TECHNICAL BULLETIN
LTB00522NAS1
22 FEB 2013

Front Door Outer Waist Seal Alignment

Range Rover (LG)

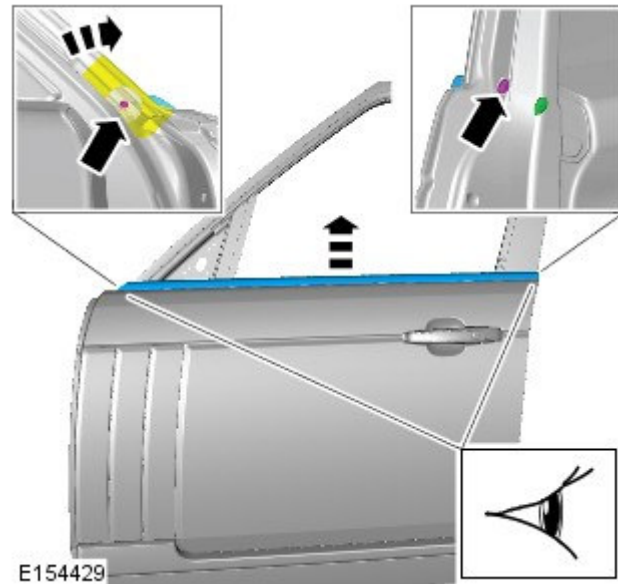
2.  **CAUTION: The exterior mirror must be**

removed prior to the removal of the waist seal; failure to follow this instruction will result in damage to the vehicle.

Remove the waist seal.

- Remove the screw cover.
- Remove the two (2) Torx screws.

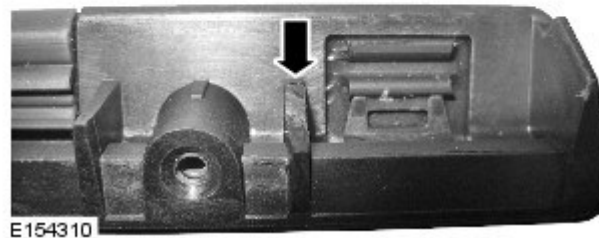
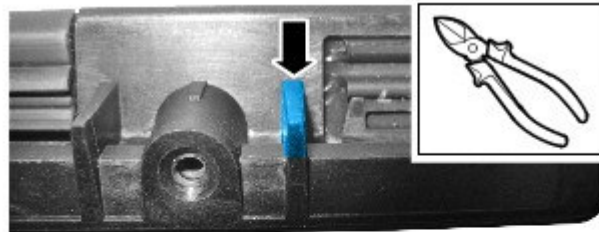
3.  **CAUTION:** Do not use a knife for this step.

**CAUTION:** Make sure the exterior surface of the waist seal is not damaged during this step.

Using a suitable tool, remove the section of plastic from the waist seal in the position shown.

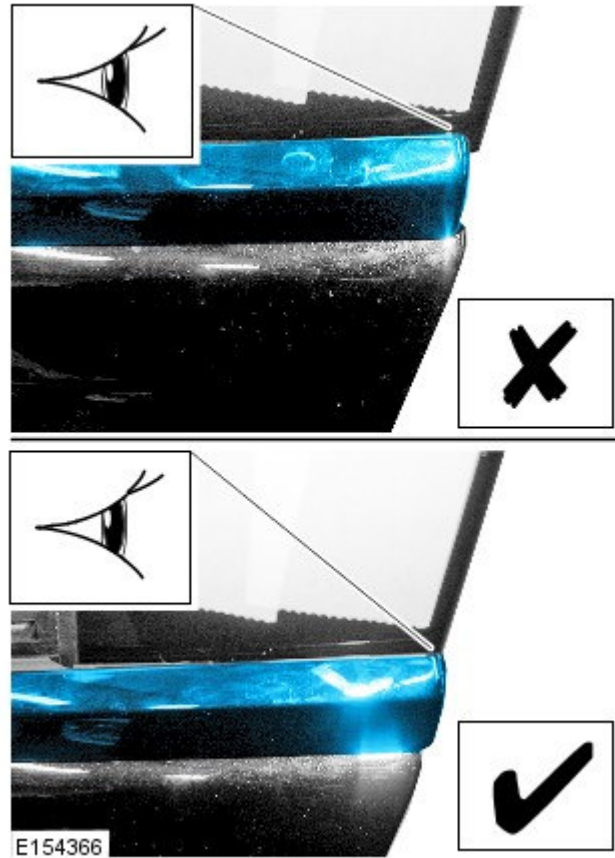
4. Install the waist seal.

- Align the rear edge of the waist seal with the rear edge of the door
- Tighten the two (2) Torx screws to 1.2 Nm.
- Install the screw cover.
